**MEMORANDUM**

**TO:** District of Columbia Zoning Commission

**SUBJECT:** **Public Hearing Report** for ZC #11-03J, Wharf Parcels 6 through 10  
First Stage PUD Modification and Second Stage PUD Application

Approved 1<sup>st</sup> Stage PUD site plan, including pier and dock layout

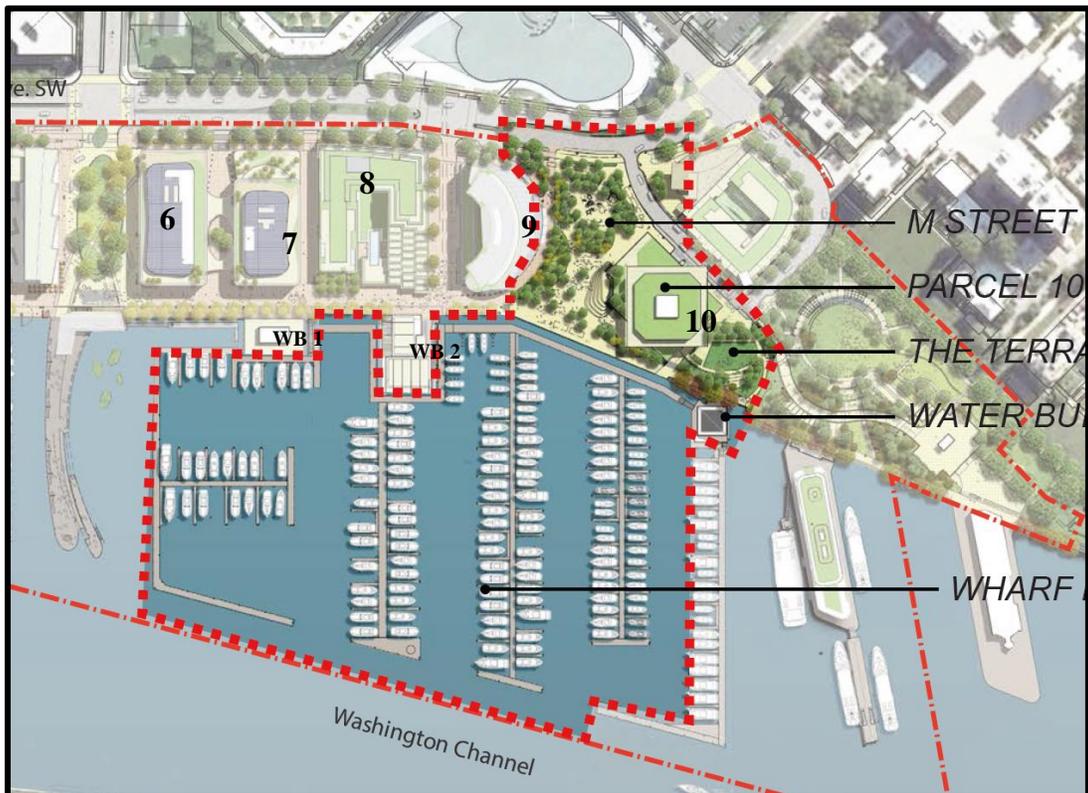
**Water Building 3 and Wharf Marina** - In response to OP and Commission comments at setdown, the applicant has requested a PUD modification for the layout of the piers, docks and water buildings. The approved first stage PUD showed a large “Commercial Pier” in the location of the current Pier 3 (the Cantina Marina Pier), which would be a rehabilitation of the existing pier or an in-kind replacement, along with an expansion. The Commercial Pier would have had a 2-story retail pavilion. As currently proposed, the water side would have no commercial pier, but would instead have docks comprising the **Wharf Marina**. The cruise boat operations formerly slated for the Commercial Pier have been moved to Pier 4, and many of the retail functions seem to have moved to Water Building 2, which has increased considerably in size.

<b>ZC / OP Comment</b>	<b>Applicant Response</b>	<b>Resolved?</b>
OP and ZC: The application should be amended to include a request for a first stage PUD modification for the layout of the piers and docks.	At Exhibit 13A, #7, the applicant requests a first stage PUD modification for these items.	Yes
